MANDATORY SERVICE BULLETIN NO. MSB 62-042 REV. 1 **SUPERSEDES MSB 62-042 REV. 0**

Rudder rib hole size correction.

It has been observed on some aircraft that some hole sizes on the rudder rib were too large. This Service Bulletin describes the procedures to add a bushing to the holes to correct the hole sizes.

WORK INSTRUCTION WI-MSB 62-042 REV. 1
SUPERSEDES WI-MSB 62-042 REV. 0

Rudder Rib Holes

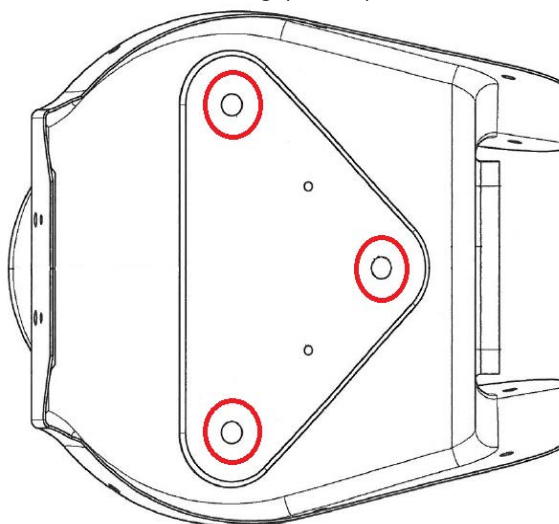
5. Carefully drill to increase the diameter of the 3 holes in the rudder rib layup to a maximum of 1 mm larger than the diameter of the bushing (Item 1).

Rudder rib section view with bushing installed

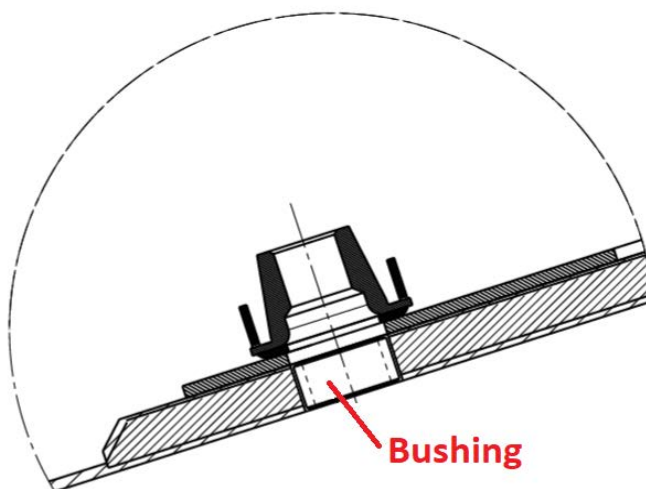
NOTE: Make sure the bushing is bonded 0.0-0.8 mm from surface on one of the sides of the composite. No protruding is allowed.

10. Reinstall the rudder control sheet using rivets (Item 3 or 3a).

Bushing specs (dimensions in metric system)

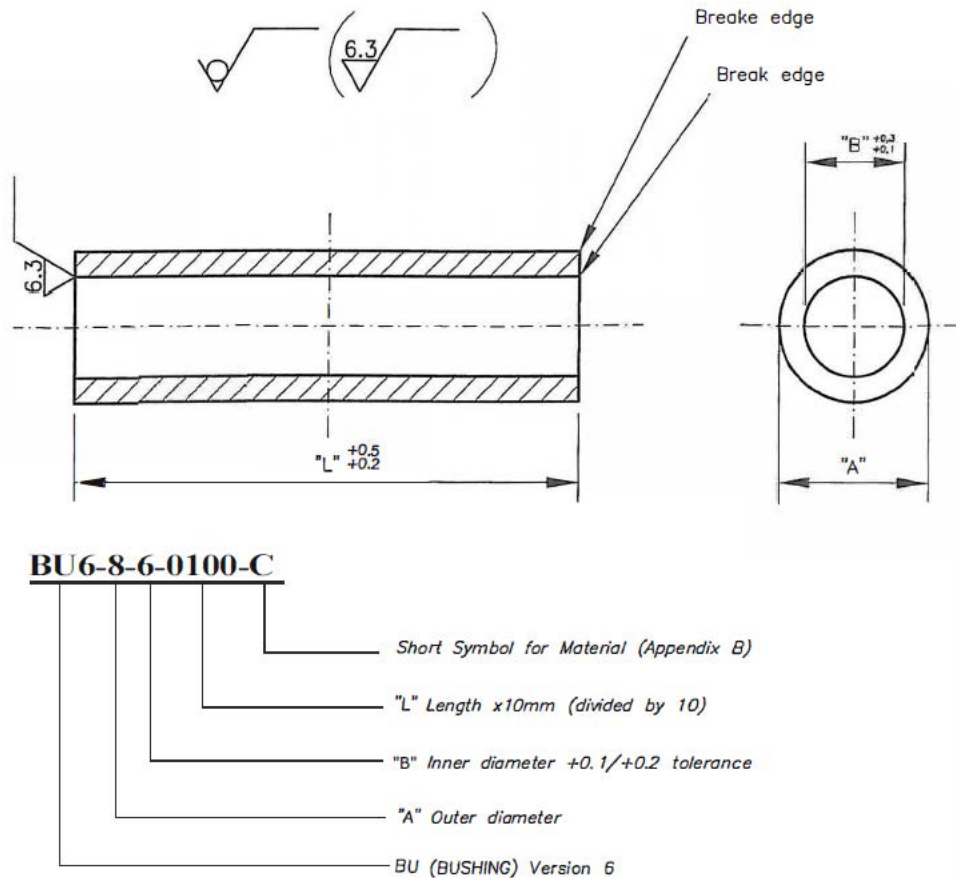
17. Follow the bushing specs below for fabrication:

NOTE: The letter 'C' in the bushing part number indicates that C1 through C4 are acceptable.
